UNITED NUCLEAR CORPORATION, HEMATITE-LICENSE AMENDMENT-  
DOCKET 70-36, DATED JUNE 7, 1953

License amendment to use D<sub>2</sub>O for the manufacture of 20% enriched UO<sub>2</sub>SO<sub>4</sub>·3D<sub>2</sub>O

Plot of ...  
Jan 14 1963

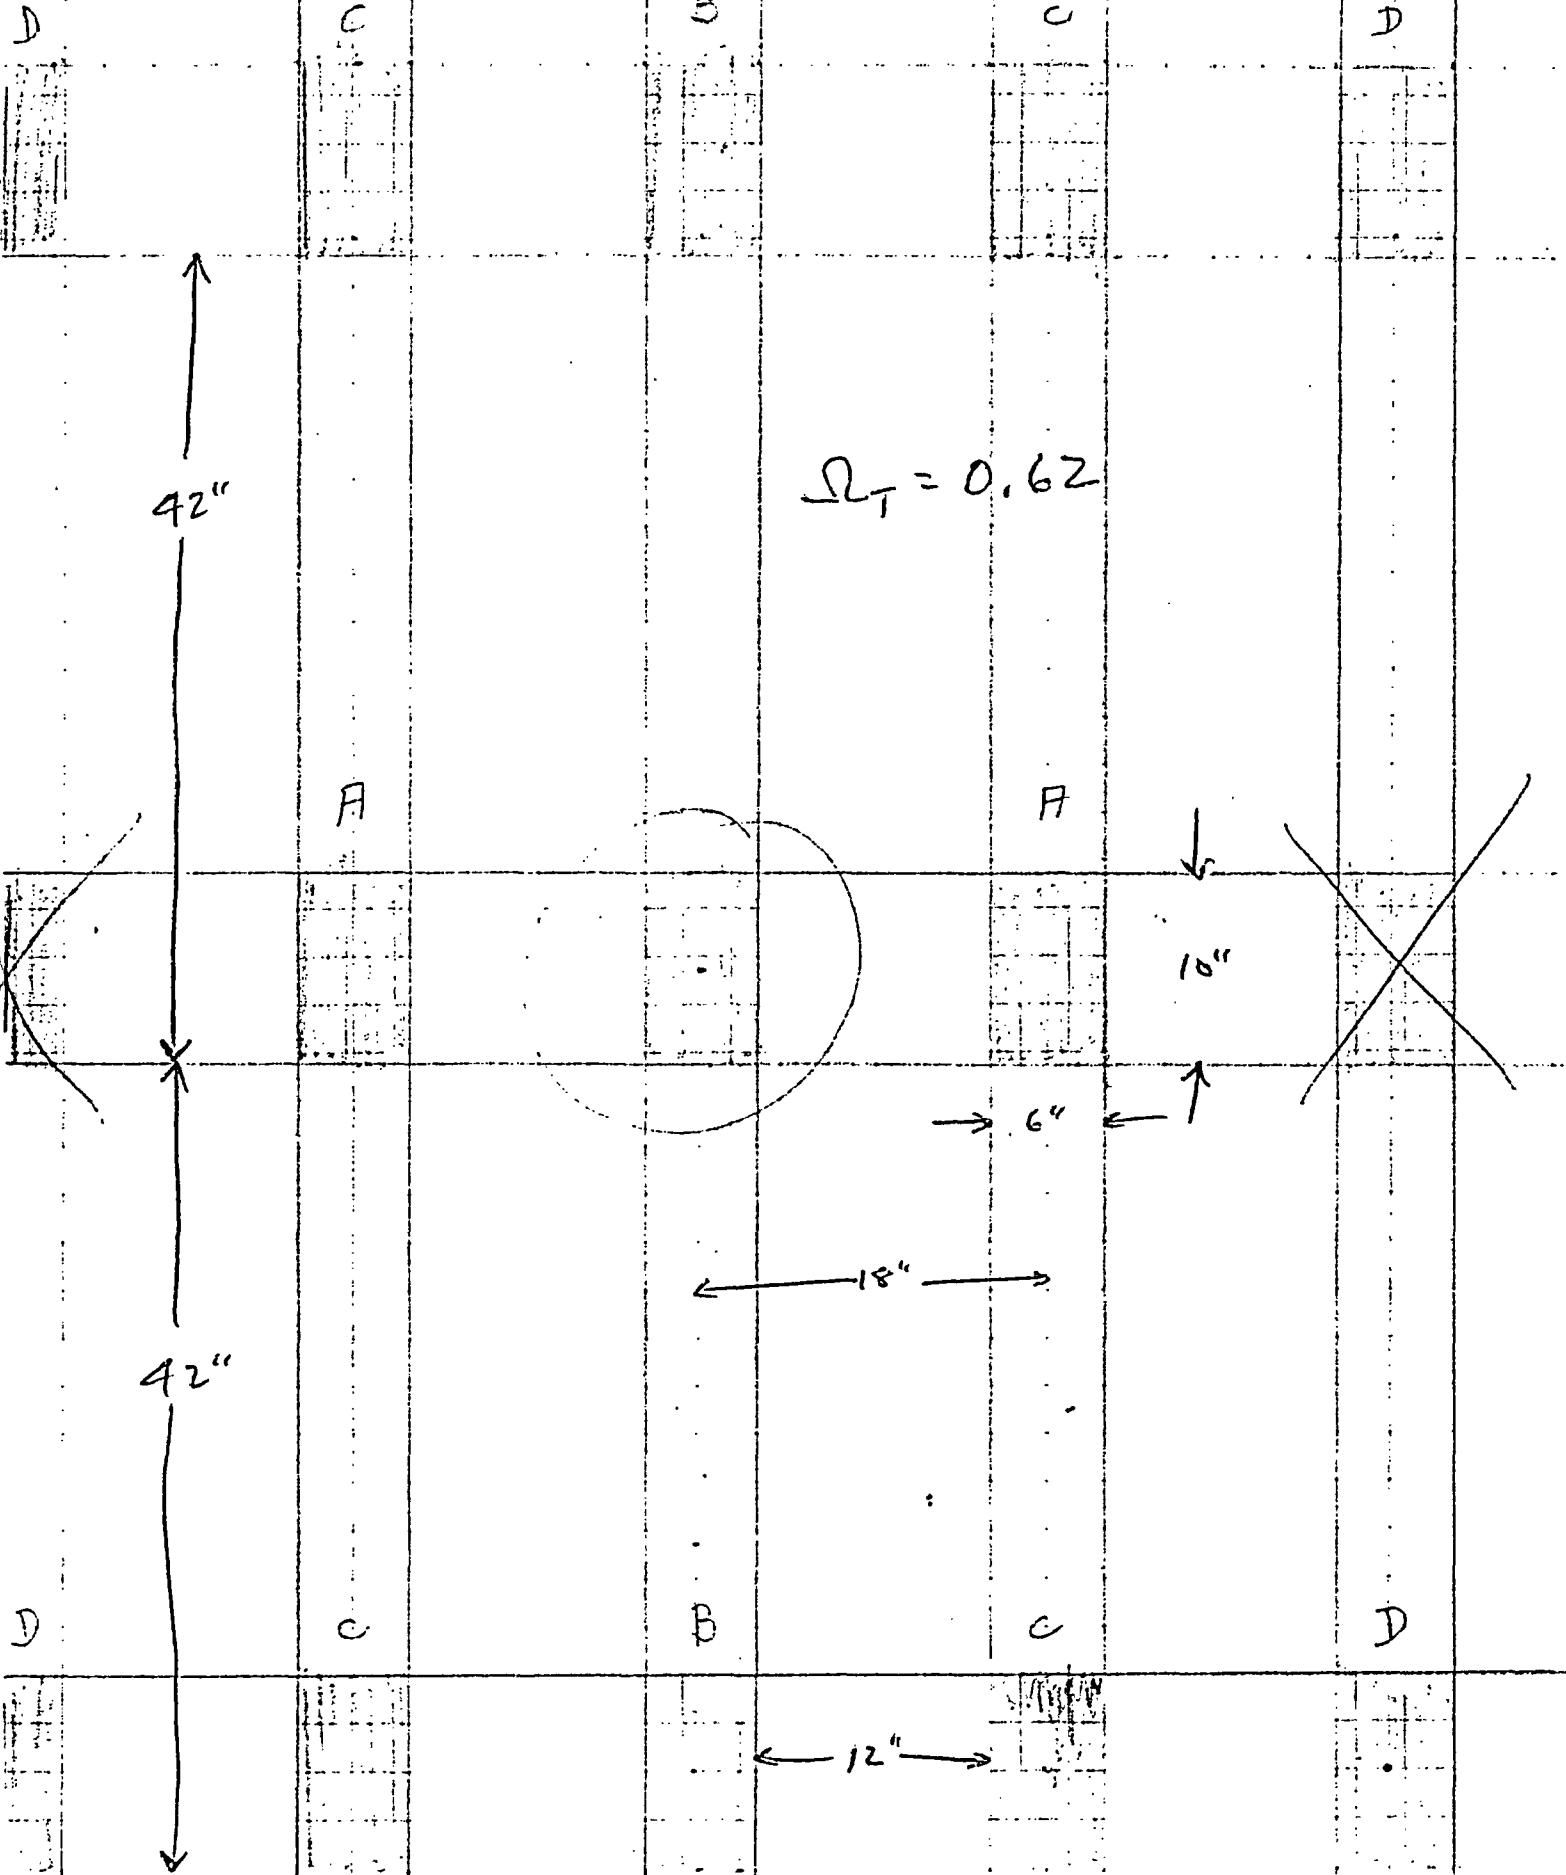
We have confirmed the nuclear safety of the applicant's storage array as shown in Figure 1. The applicant has proposed to store in safe mass quantities, and, therefore, assumed a multiplication factor of 0.65 for each unit. The solid angle subtended in the central storage bottle is much less than the permissible 2.5 steradians for this value of the multiplication factor.

The applicant should confirm that this storage array will be isolated from all other special nuclear material (licensed and contract) as given in Part 70.57 or submit a nuclear safety analysis to demonstrate the array is safe even though it is not isolated.
